# ***ESSEX COUNTY OFFICE OF COMMUNITY RESOURCES***

**SUBJECT:** Addendum #2 Newcomb Community & Historical Center Center Architectural RFP

**1. Update to Appendix B - Project Reference Data**

# PROPOSED NEWCOMB HISTORIC WELCOME CENTER

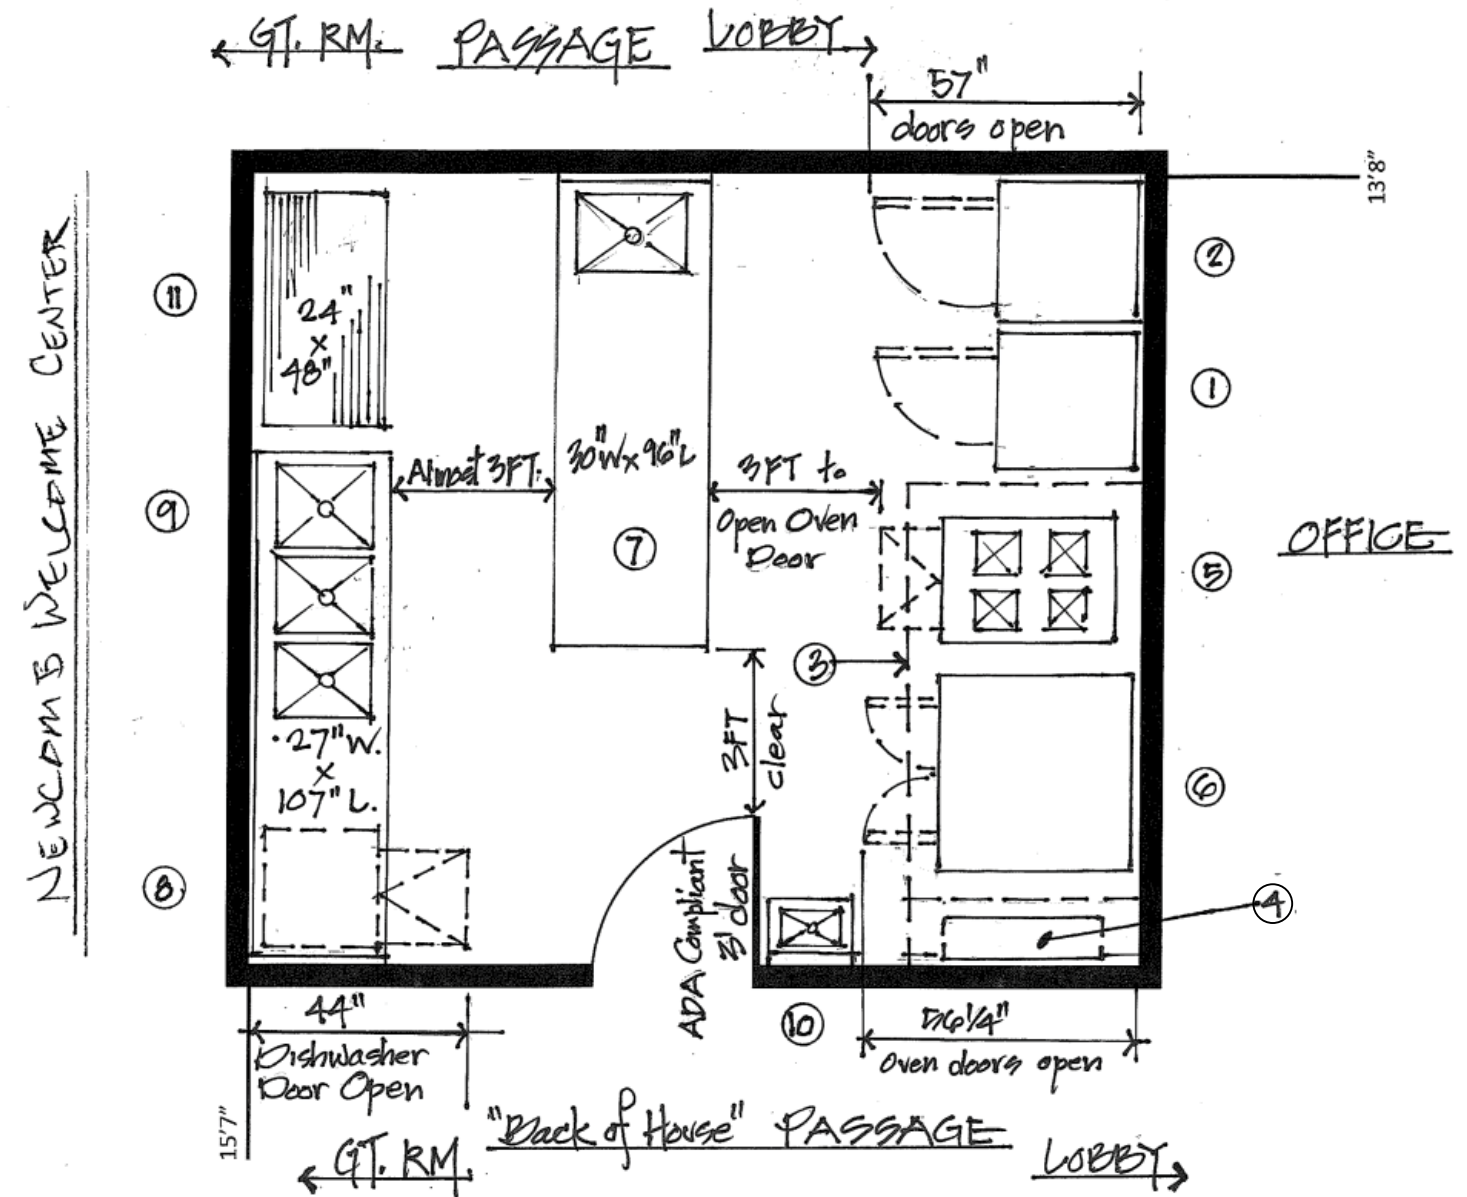
As you can see from the sketch, the designated area is rather small for the equipment desired. Short of making the actual area larger, space could be gained by changing the full size convection oven (Item #6) to a half size unit and perhaps changing the single section reach-in refrigerator (Item #1) to an undercounter unit that could be located beneath the prep table (Item #7). The determining factor in making these changes would be the type of functions that the area would have to accommodate as well as the number of customers/guests that would be served. We would also suggest that stainless steel sink bowl covers be provided for the three (3) scullery sink bowls so that the unit could be used as a work surface when not in operation as a scullery area.
